Proposition on IEEE802.1AEef

IEEE 802 Interim – Security Working Group

May 10-15, 2026

Figure 14-2—Ascon-XPB-128 Nonce construction

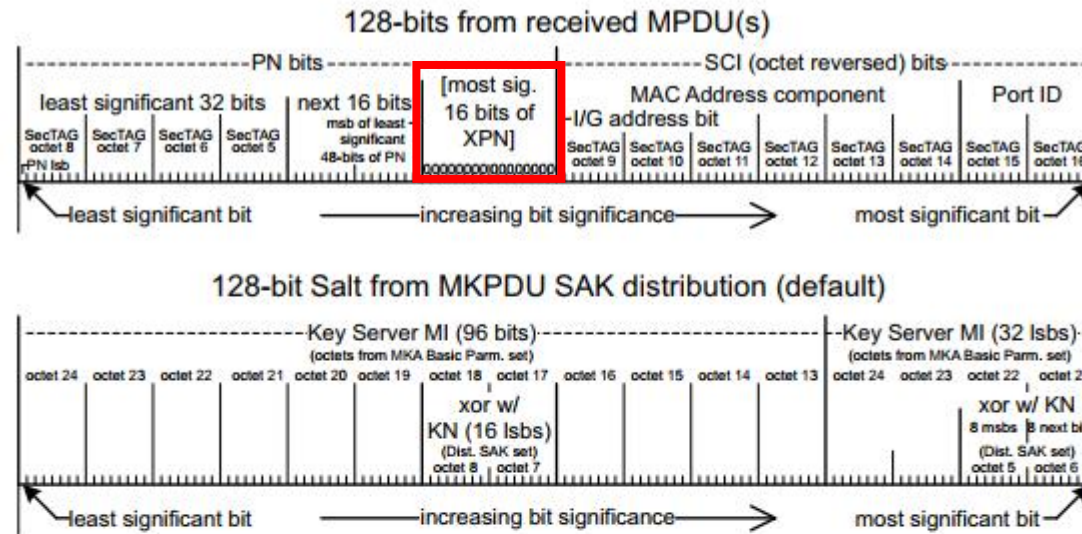
- Reducing the A to 14 octets, i.e., $A^* = DA || SA || EtherType,$
- Resulting in **one** 16 octet Ascon-p[8] block, i.e., $A_1 = A^* || 1 || (0)^{15}$
- Moving the last two octets of the SECTag to the IV, more precisely to the most significant 16 bits of the XPN, which are currently filled by zero.

Illustration of Reduction for Confidentiality Protection

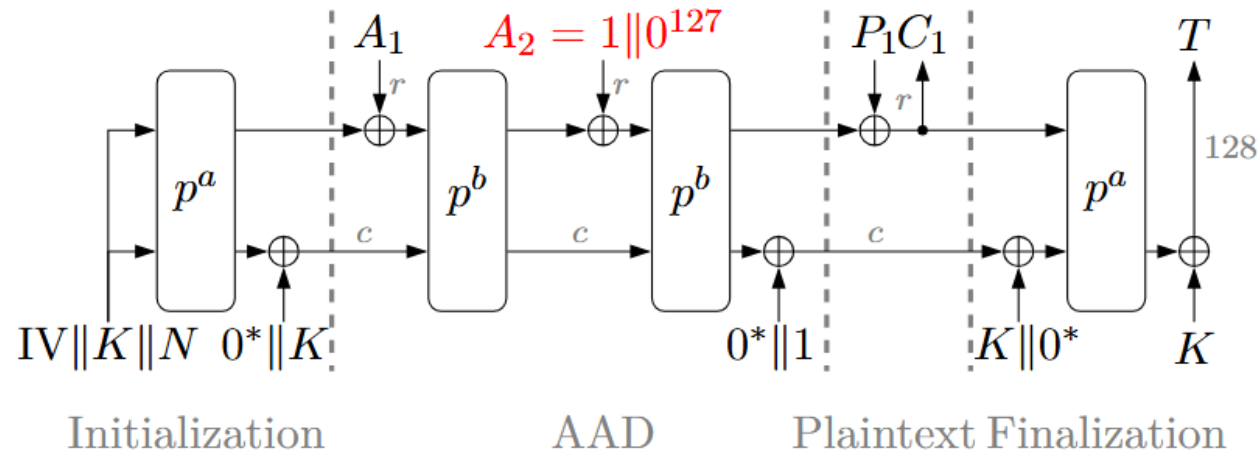
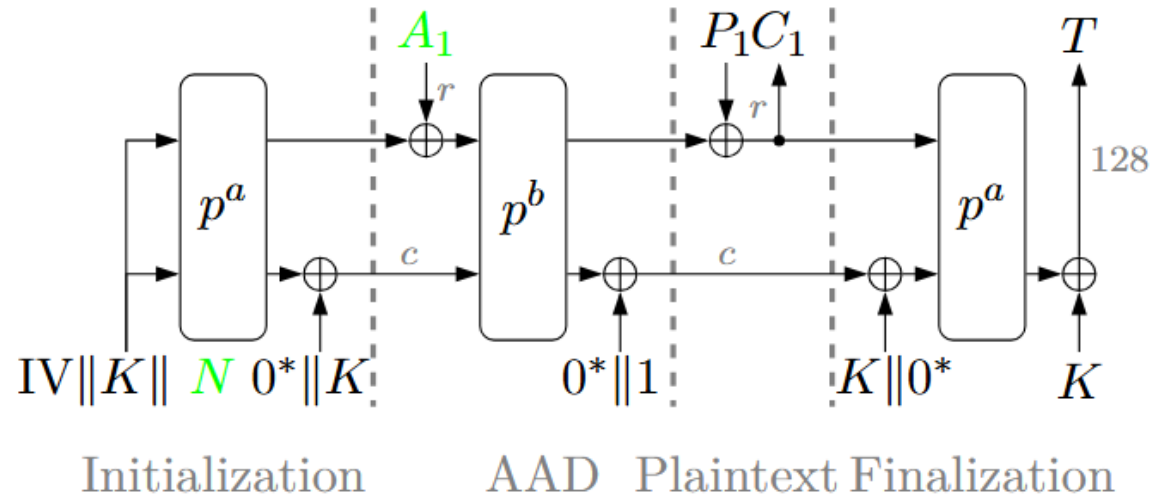
$$A_1 = DA \parallel SA \parallel \text{EtherType} \parallel \text{TCl+AN+SL}$$

$$A_2 = 1 \parallel (0)^{127}$$

$$A_1 = DA \parallel SA \parallel \text{EtherType} \parallel 1 \parallel (0)^{15}$$

Complexity **Ratio** for |MSDU| < 16 for a=12 and b= 8 is

$$\frac{a + b + a}{a + b + b + a} = \frac{32}{40} = \frac{4}{5}$$

Illustration of Reduction for Confidentiality Protection

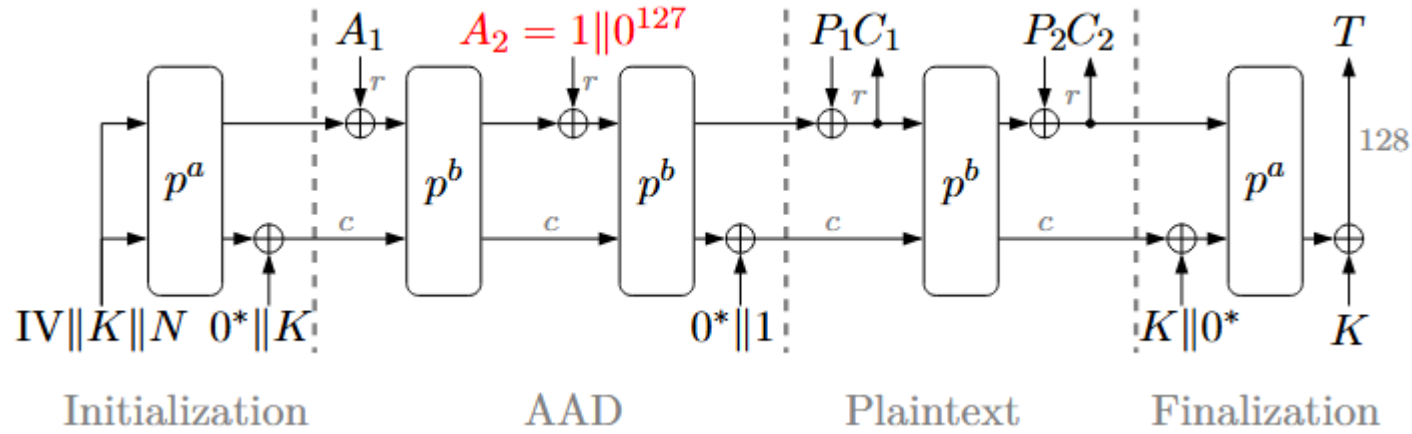
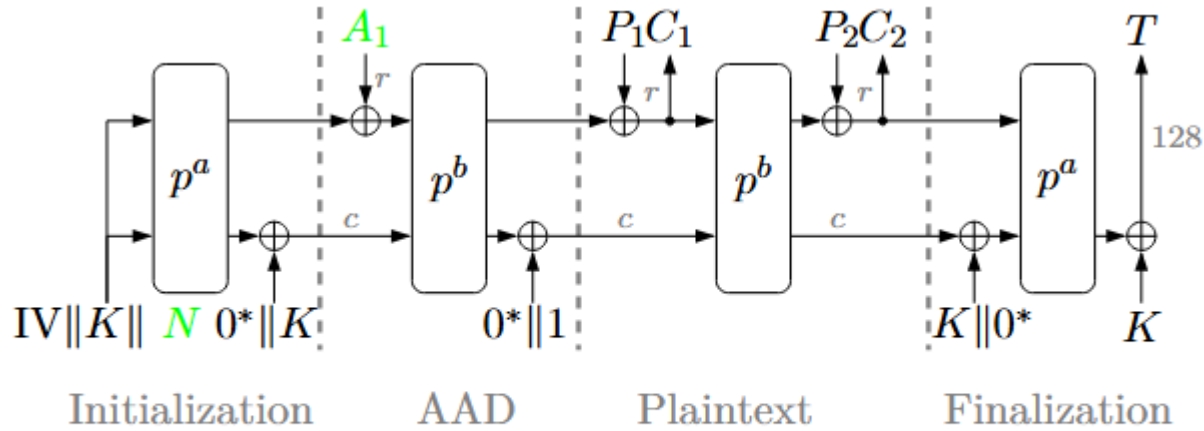
$$A_1 = DA \parallel SA \parallel \text{EtherType} \parallel \text{TCl+AN+SL}$$

$$A_2 = 1 \parallel (0)^{127}$$

$$A_1 = DA \parallel SA \parallel \text{EtherType} \parallel 1 \parallel (0)^{15}$$

Complexity **Ratio** for |MSDU| = 16 for a=12 and b= 8 is

$$\frac{a + b + b + a}{a + b + b + b + a} = \frac{40}{48} = \frac{5}{6}$$

Complexity Reduction For Confidentiality Protection (R_C) and Integrity Protection (R_I)

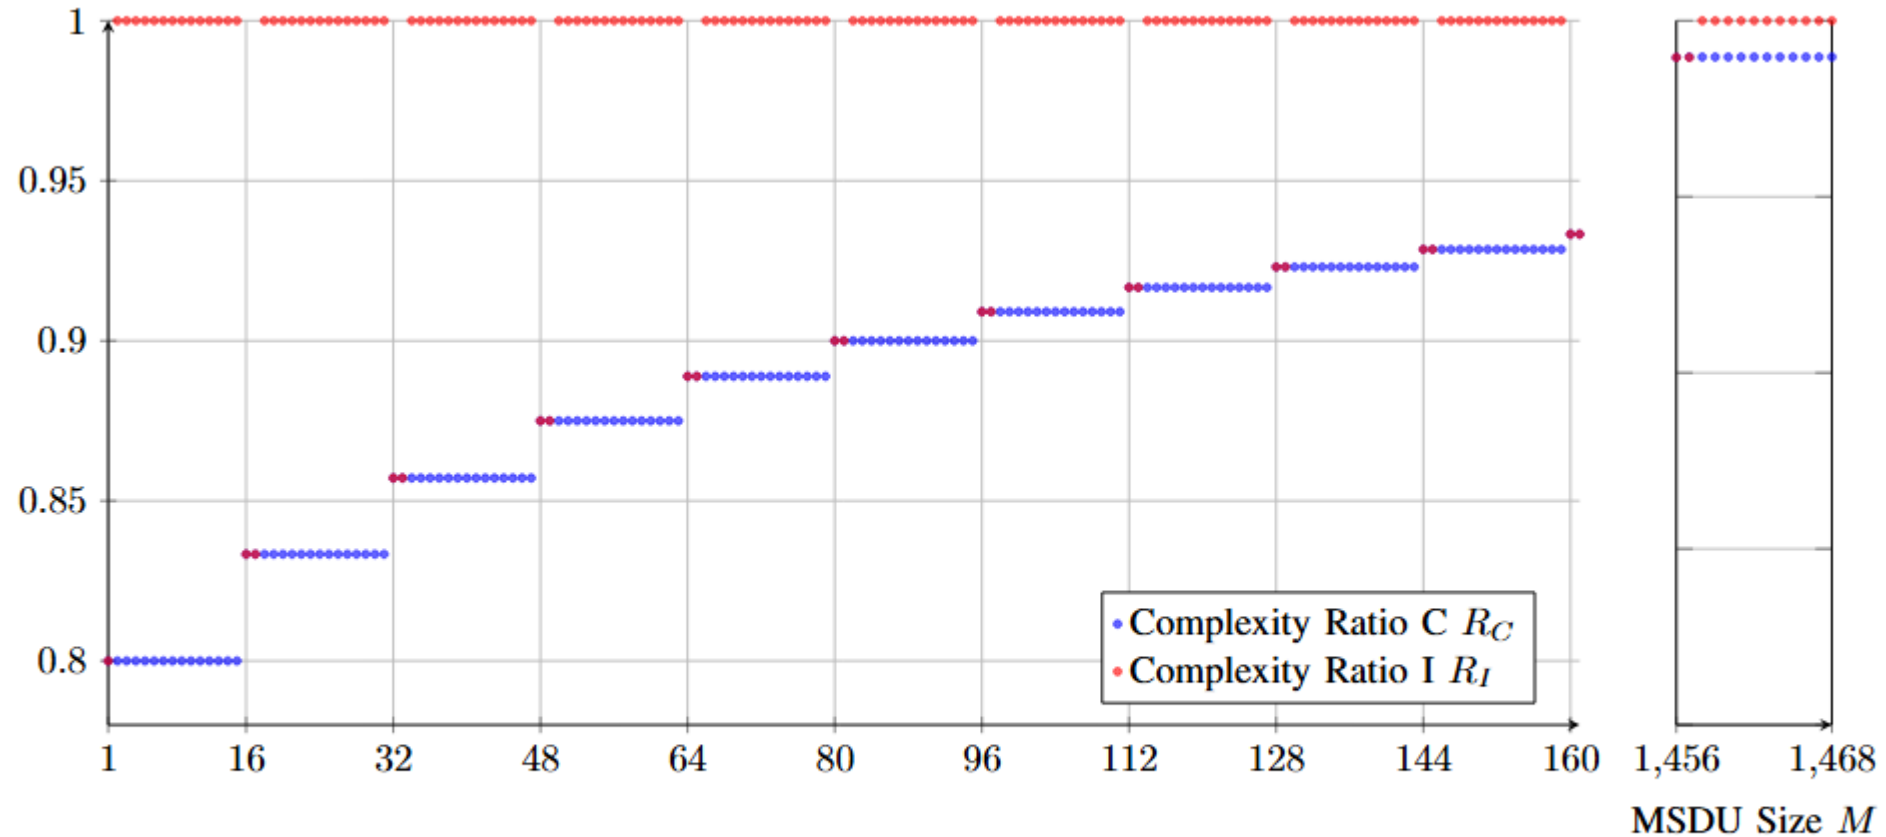
Fig. 2. Complexity ratios of Ascon* relative to Ascon are shown for confidentiality protection $R_C(M)$ (blue) and integrity protection $R_I(M)$ (red). For integrity protection a reduction of complexity $R_I < 1$ occurs for only for $M \bmod 16 = \{0, 1\}$. In contrast, confidentiality protection achieves reduced complexity $R_C < 1$ for all values of M . Notably, for short frames with $M < 96$ the complexity is reduced by more than 10 %.
